SERVICE PROCEDURE

22524 / 22553
JANUARY, 2023

VEHICLE RECALL 22553

Figure 2. HAS Cross Brace

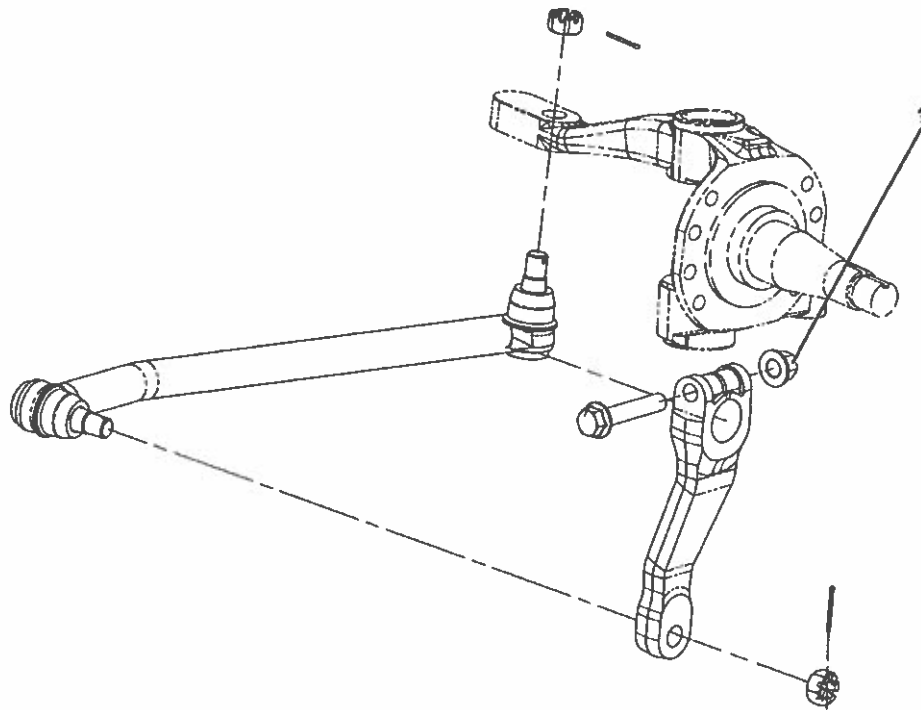
9. Access four nuts (Figure 2, Item 1) securing rear axle(s) to cross brace.

10. Remove and replace nuts one at a time. Using a torque wrench, tighten nuts to 330 - 370 lb-ft (450 - 500 N·m).

Figure 1. TRW Pitman Arm Nut

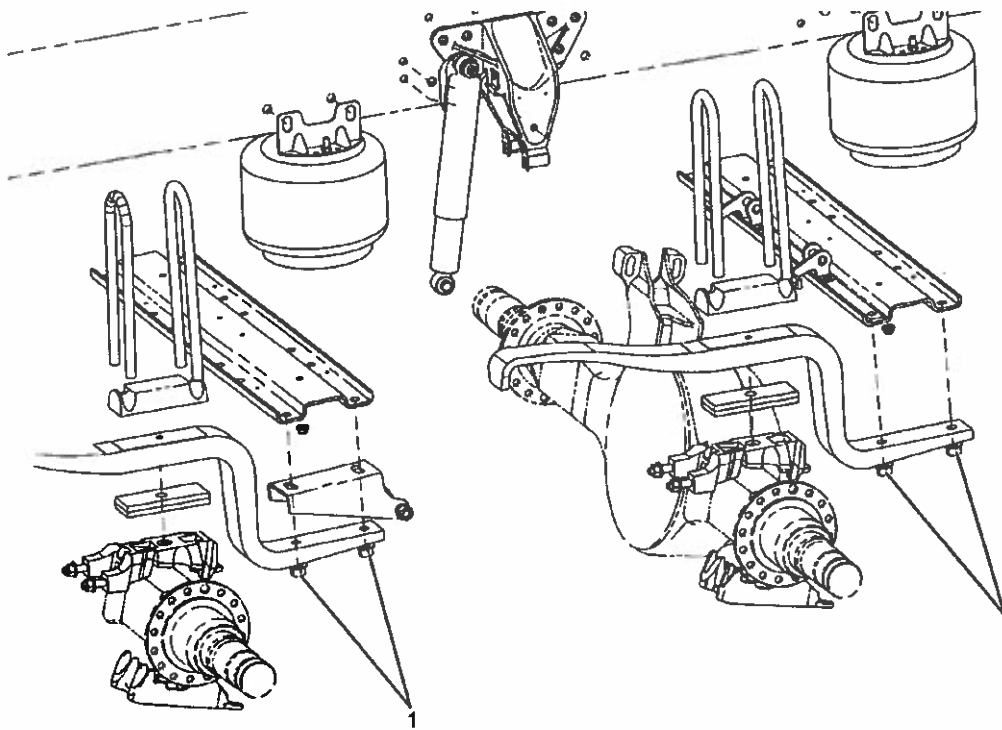
6. Access Pitman arm nut (Figure 1, Item 1).

7. Remove and replace nut. Using a torque wrench and backup wrench positioned on bolt, tighten nut to 330 - 370 lb-ft (450 - 500 N·m).
8. Using jack, raise rear axles and support vehicle on jack stands.
